# HISTORIC AND DESIGN REVIEW COMMISSION

**HDRC CASE NO:** 2024-053  
**ADDRESS:** 515 VILLITA ST  
**LEGAL DESCRIPTION:** NCB 142 BLK LOT 11  
**ZONING:** D, H, RIO-3  
**CITY COUNCIL DIST.:** 1  
**DISTRICT:** La Villita Historic District  
**APPLICANT:** Samuel Panchevre/Alamo City Investments  
**OWNER:** San Antonio Conservation Society Panchevre/Casa Catrina  
**TYPE OF WORK:** Construction of a terrace on the river side, installation of graphics and signage  
**APPLICATION RECEIVED:** January 24, 2024  
**60-DAY REVIEW:** March 24, 2024  
**CASE MANAGER:** Edward Hall  
**REQUEST:**

The applicant is requesting a Certificate of Appropriateness for approval to:

## Gazebo Casa Catrina

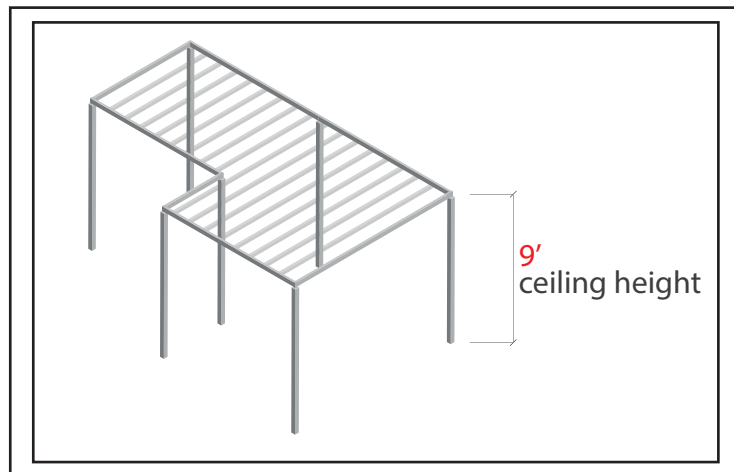
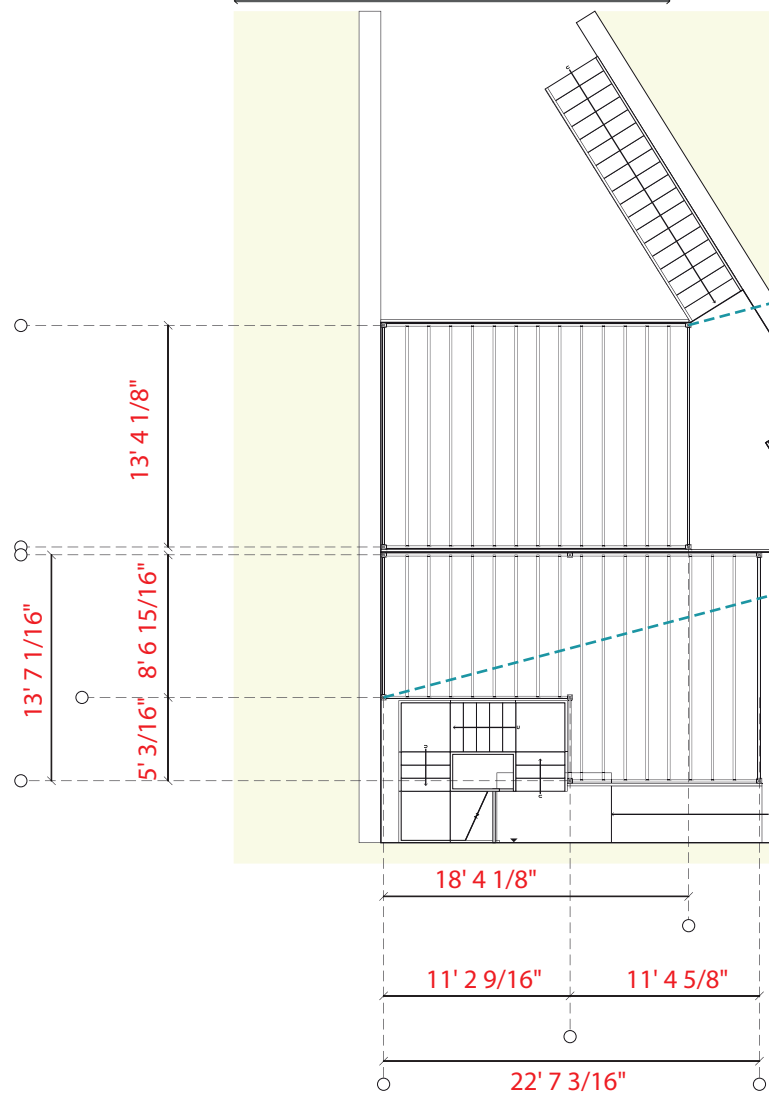
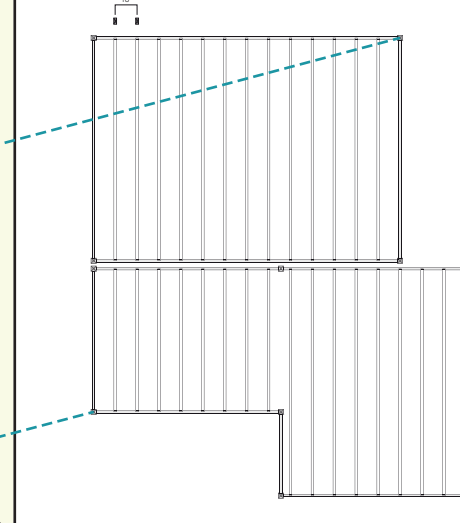
- c. TRELLISES – The applicant has proposed to construct a series of metal trellis structures to provide cover and shade for the terraced seating area on the river side of the property. The applicant has proposed for the trellises to be constructed of metal, featuring 4x4 metal columns with both metal perimeter beams and wood interior beams, and to be painted gray. The applicant has noted that the trellis structures will feature varying heights of eight (8) to nine (9) feet. The applicant has noted that the design will accommodate a water feature; however, the applicant has not provided additional information on this. Generally, staff finds the proposed trellis structure to be appropriate. All elements should be painted to complement the existing tones and colors found historically on site. The installation of the proposed trellis structures should not result in rainwater draining onto the public pathway at the River Walk.

- 1. Staff recommends approval of item #1, the construction of a series of metal trellises based on finding c, with the following stipulations:
  - i. That the trellises be painted to complement the existing tones and colors found historically on site.
  - ii. The installation of the proposed trellis structures should not result in rainwater draining onto the public pathway at the River Walk.
- 2. Staff recommends approval of item #2, the installation of wood railings based on finding d with the stipulation that bolts are installed in mortar joints rather than through stone elements.

**Restaurant entrance logo**

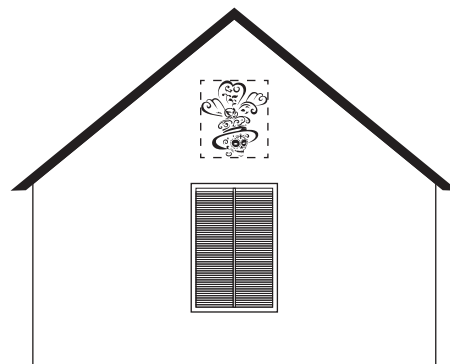
- e. BALCONY LEVEL SIGNAGE – The applicant has proposed to install balcony level signage facing Villita Street. Generally, staff finds balcony level signage to be appropriate; however, staff finds that the signage should be installed as a hanging sign rather than applied to the balcony wall. Historically, balcony level signage is installed in this manner.

3. Staff recommends approval of item #3, the installation of balcony level signage with the stipulation that the signage be installed as hanging signage and not wall signage.
4. Staff does not recommend approval of item #4, the installation of a graphic/sign beneath the gable. Staff does not find this signage location to be consistent with the Guidelines nor appropriate within the La Villita Historic District.

**Building Logo**

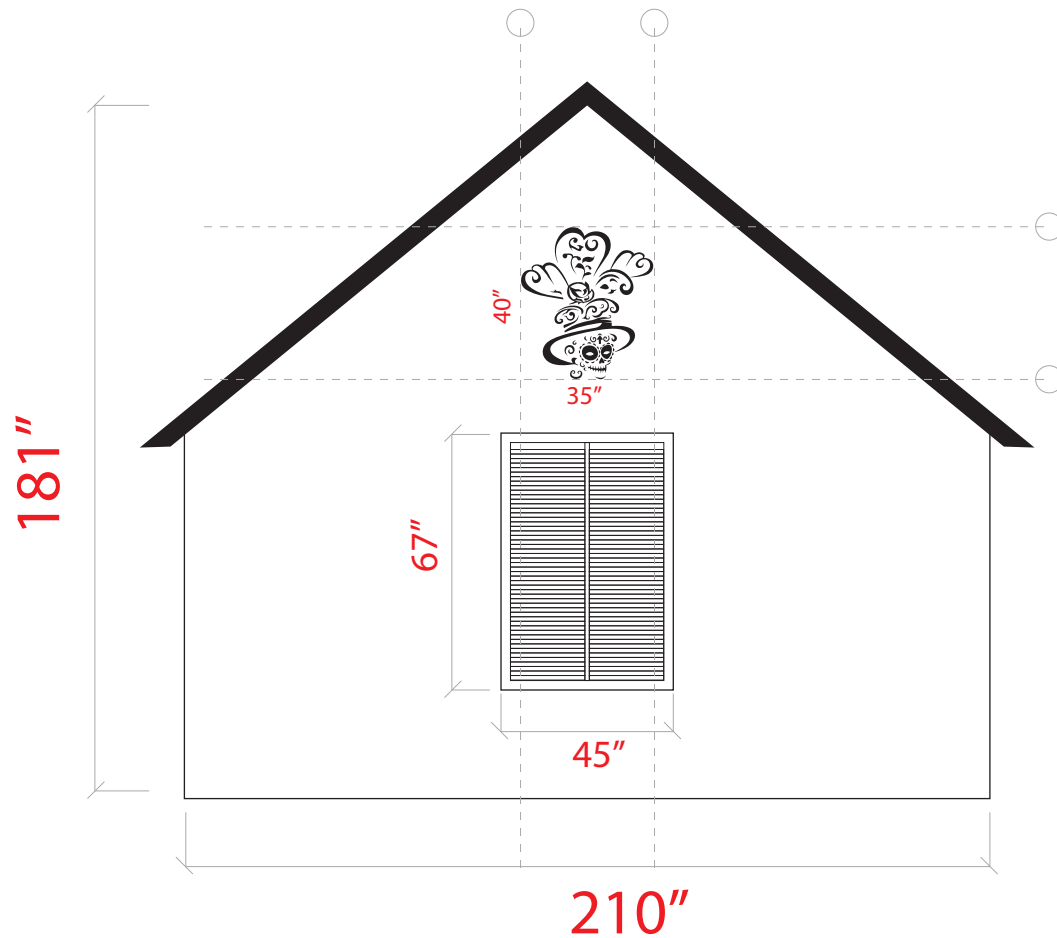
- f. GABLE SIGN – The applicant has proposed to install one wall sign beneath the street facing gable. The Guidelines for Signage notes that wall signs should be located on building forms that historically featured wall signs. Generally, staff finds this location to be inconsistent with the Guidelines as signage did not exist here historically. Staff recommends this sign be eliminated.
